**AF05 - Checking and Reworking Wire Harness for Left Rear Radiator Fan (Stop Sale Campaign/Recall Campaign)**

Vehicle Type: **918 Spyder**

Model Year: **2015**

Concerns: **Wire harness for rear left radiator fan**

*Assessment of wire harness  
for radiator fan*

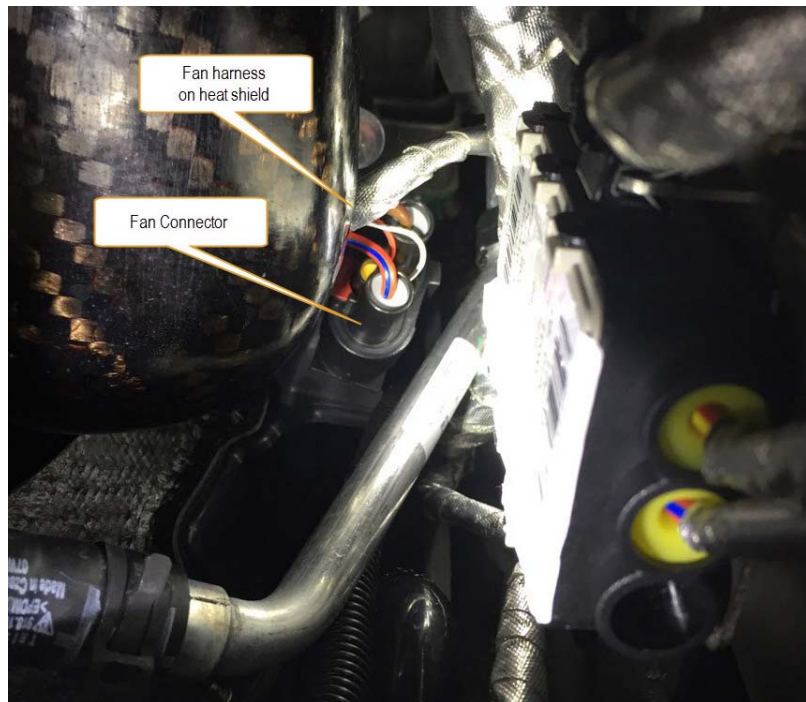
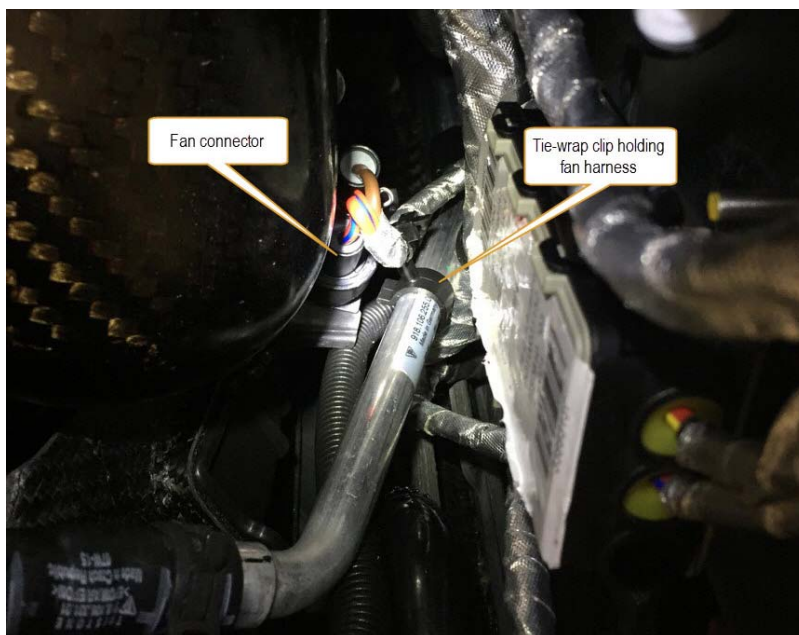
- 1 Visually inspect the wire harness using the endoscope or using a suitable inspection mirror and check for visible chafing marks on the wire harness for the radiator fan.
  - If there are no chafing marks visible on the wire harness, fit the tie-wrap clip and reassemble the vehicle. To do this, **continue with Step 2**.
  - If there are visible chafing marks on the wire harness, take photos of these using the endoscope or a digital camera and attach the photos to the PQIS job and submit a PTEC-TLAR to PCNA for further instructions.

1.1 Before and after pictures to use as a reference.

*Fitting tie-wrap clip*

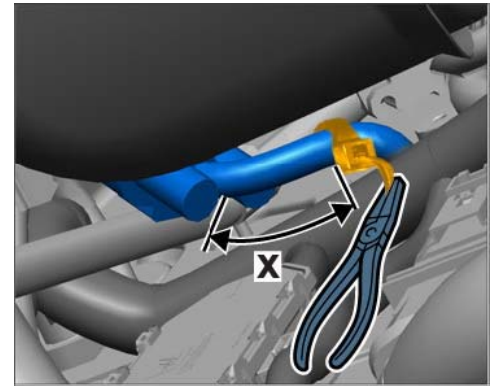
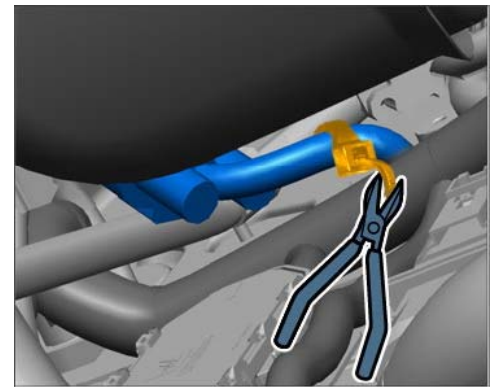
To prevent damage to the wire harness over the service life of the vehicle, the wire harness for the radiator fan must be secured to the water tube in the heat guide plate area.

- 2 Fit tie-wrap clip on wire harness for radiator fan.
  - 2.1 Fit tie-wrap clip around the wire harness as shown ⇒ *Fitting tie-wrap clip* and close it, but do not tighten it yet.

Depending on how the harness is routed, it may be difficult to reroute to the desired position as shown in the diagram. In this case, it is important to assure that the harness is sufficiently pulled away from the heat shield to avoid any potential contact.

*Securing tie-wrap*

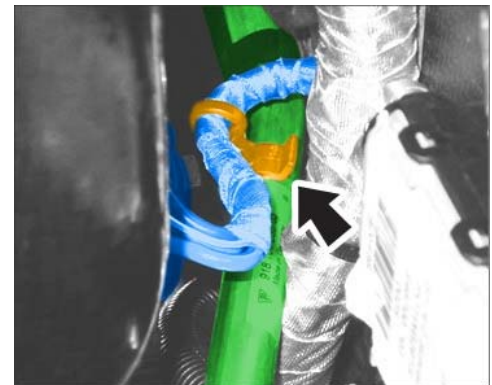
- 2.2 The tie-wrap clip should be secured at a defined distance from the connector on the wire harness.  
To do this, measure a distance of  $\Rightarrow$  *Securing tie-wrap - X = 70 mm*- from the lower edge of the connector using a ruler and mark this position on the wire harness.
- 2.3 Position tie-wrap clip at the marking and tighten it using needle-nose pliers.
